SANDSTONE PRECINCT

23-39 BRIDGE STREET
SYDNEY NSW, 2000

**PROPOSED PLANS - LANDS BUILDING -
LOWER GROUND, EDUCATION BUILDING -
BASEMENT 01**

FOR APPROVAL

Date Printed: 20/7/20

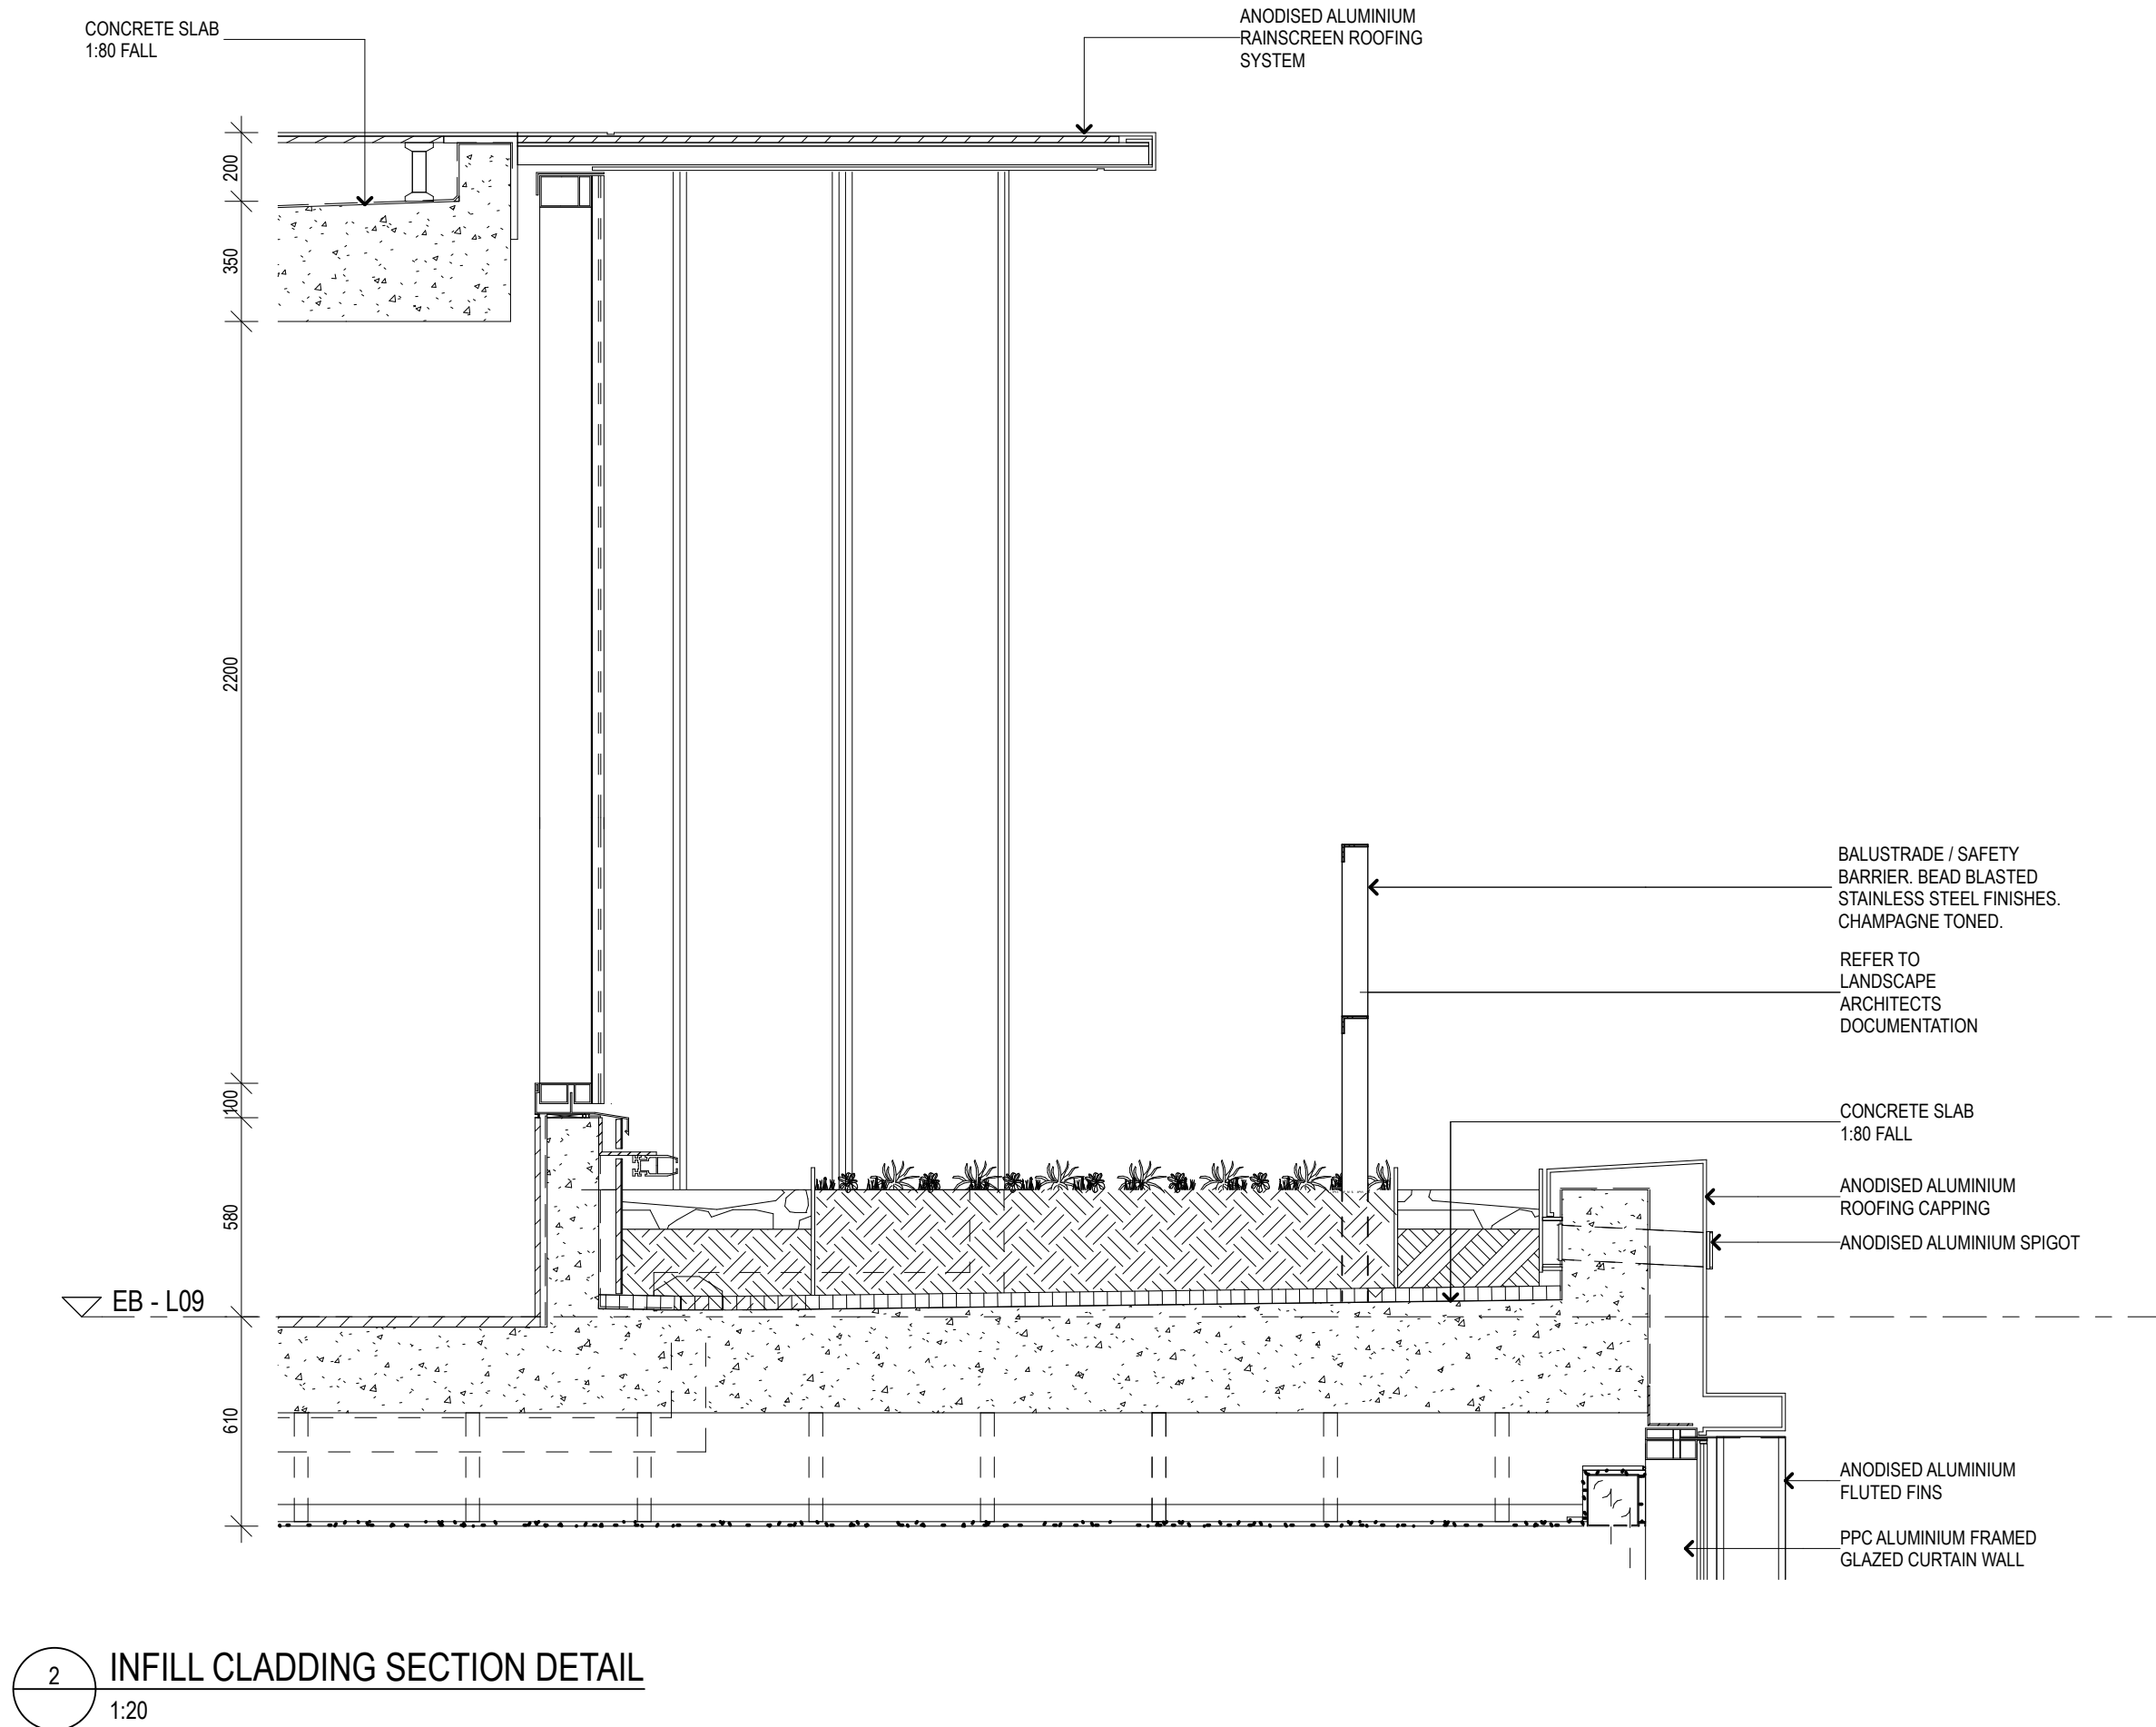
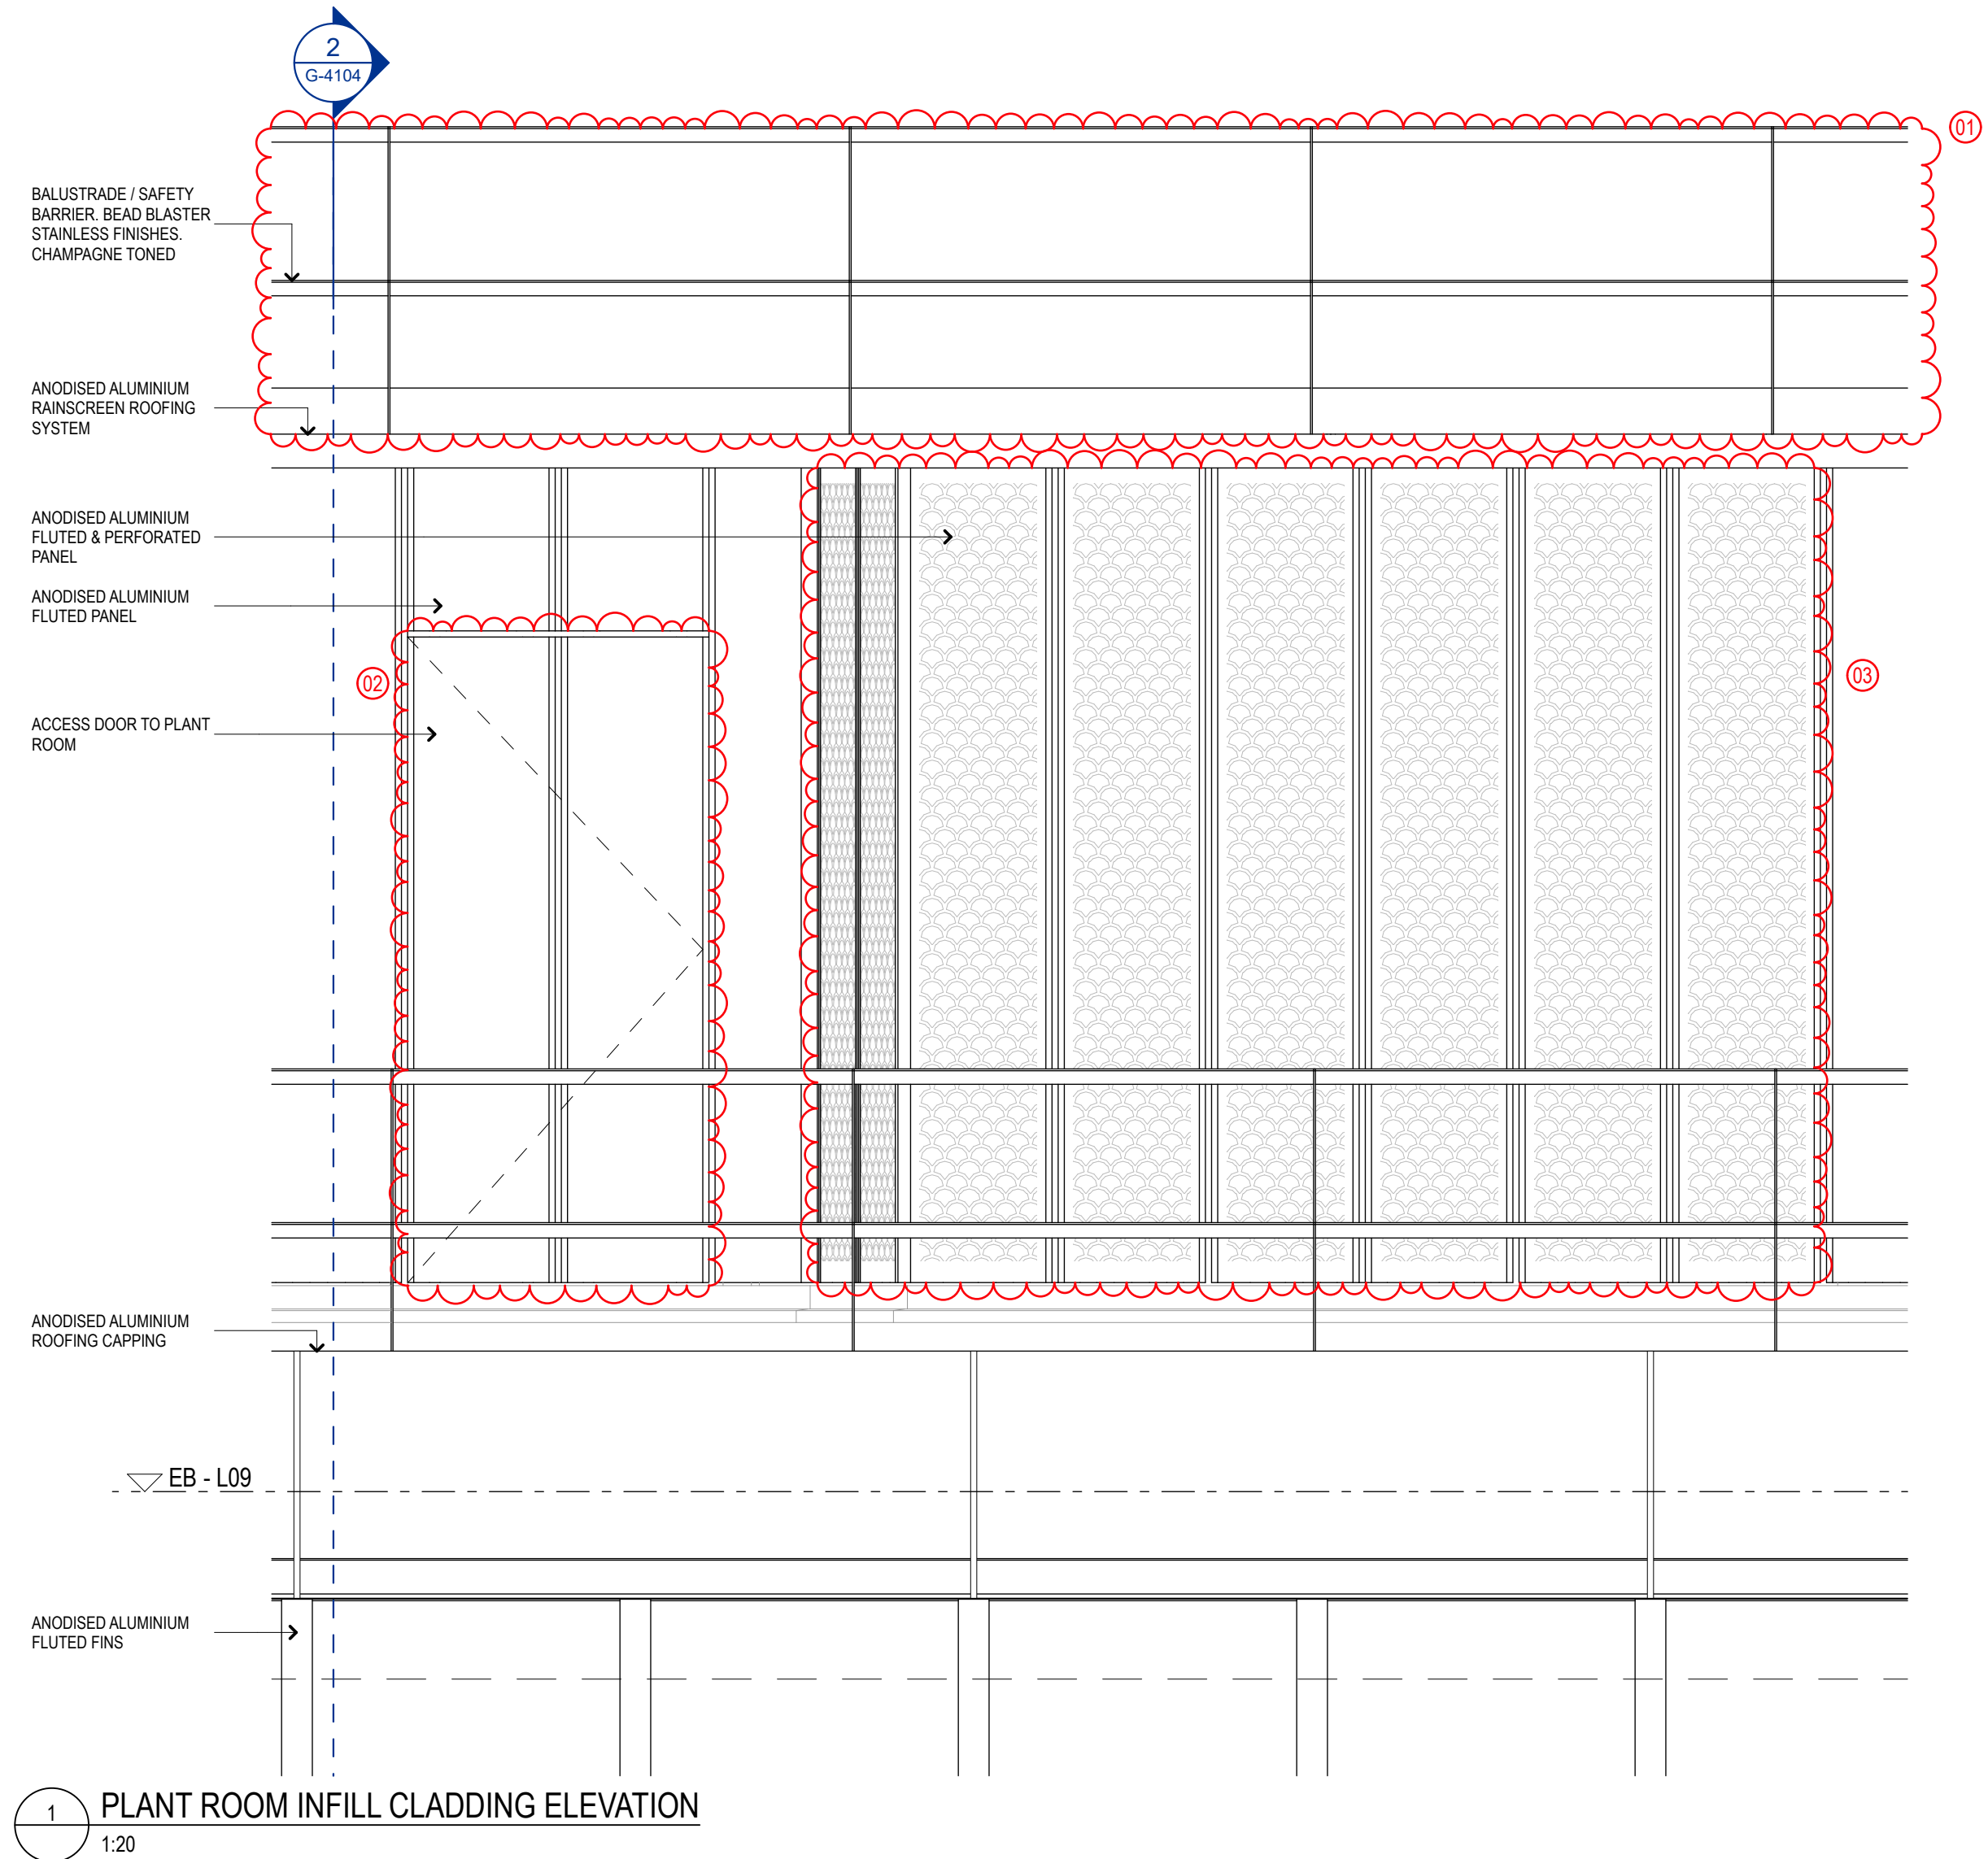
- CHANGES LEGEND:
- 01 ADDED BALUSTRADE
 - 02 ACCESS DOOR RELOCATED
 - 03 PERFORATED PANELS RELOCATED
